SERVICE BULLETIN

Fuel pump contamination possible on 440 Kohler

Bulletin No: JC-13-01

Product Type: Steiner 440 with Kohler Engine

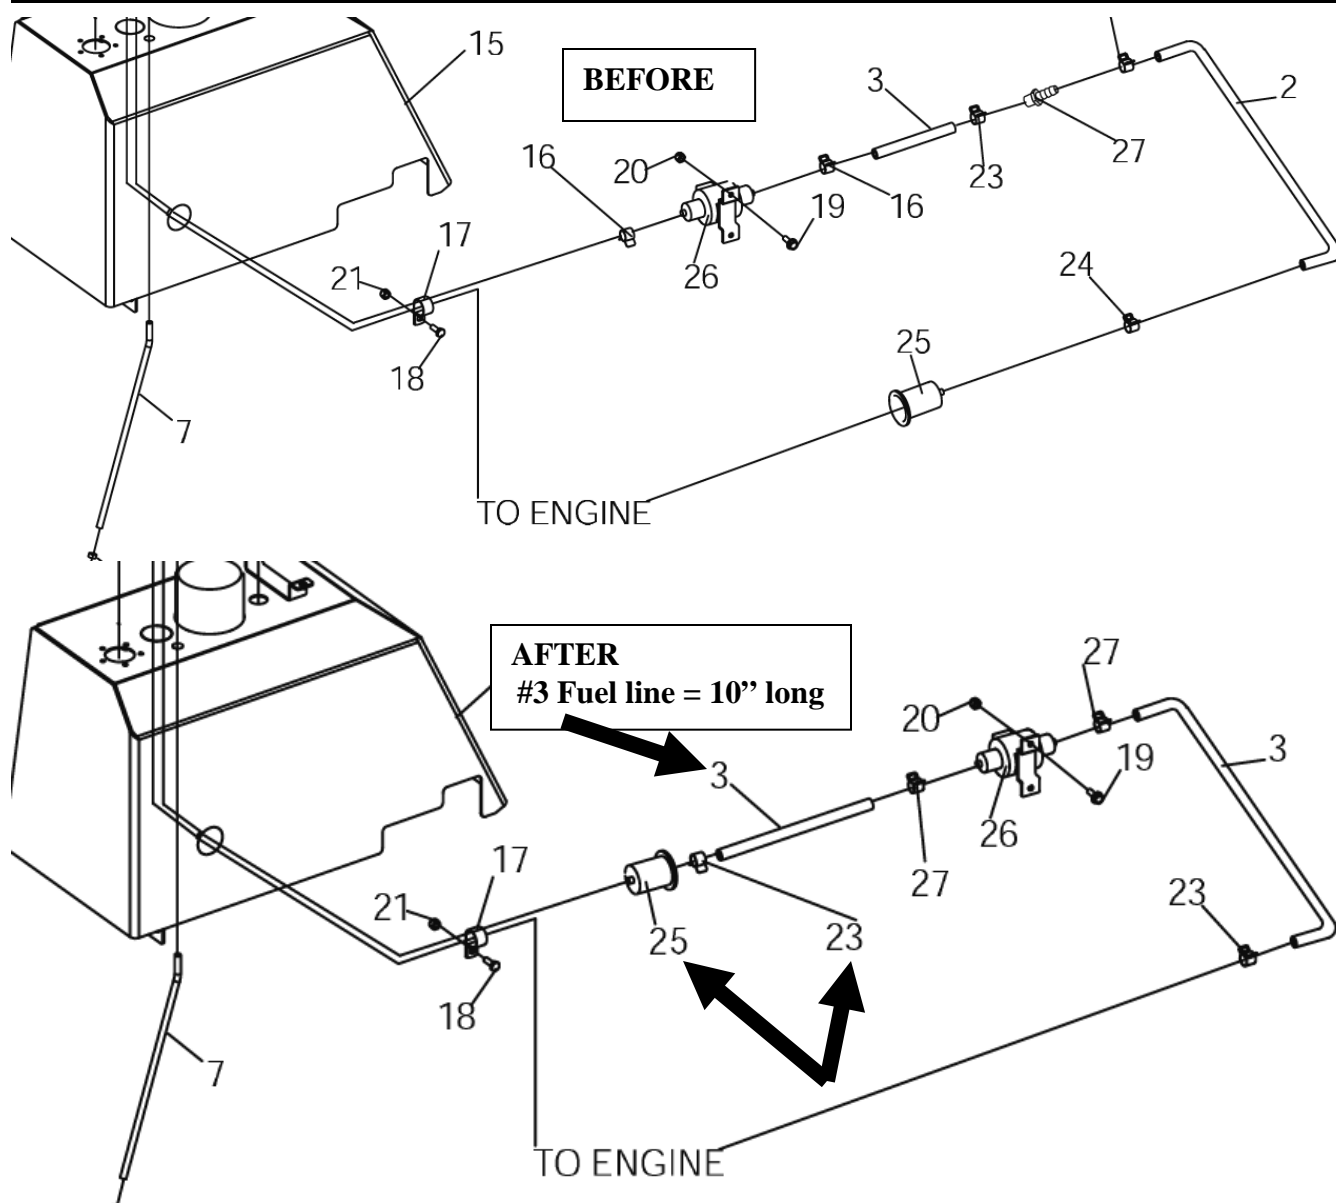
Cause: Contaminants from the fuel tank can damage the fuel pump not allowing it to pump fuel

Action required: Install a fuel filter between the tank and the fuel pump. See page 2.

1. Order these parts: 1 of 13-12581-43012 fuel filter (ref 25) and 2 of 88042-02 5/16 clamp (ref 23).
2. Locate and clamp the fuel line coming out of the tank with a fuel line clamp.
3. Measure back 10" from the fuel pump and cut the fuel line. Use caution. A small amount of gas will drain out of the fuel line.
4. Cut approximately 2.25" of fuel line off of the fuel line attached to the tank.
5. Install the clamps and fuel filter, making sure the filter is turned properly for proper fuel flow.
6. Release the fuel line clamp and check for leaks.
7. Run the engine and let it bleed out the air in the fuel line.
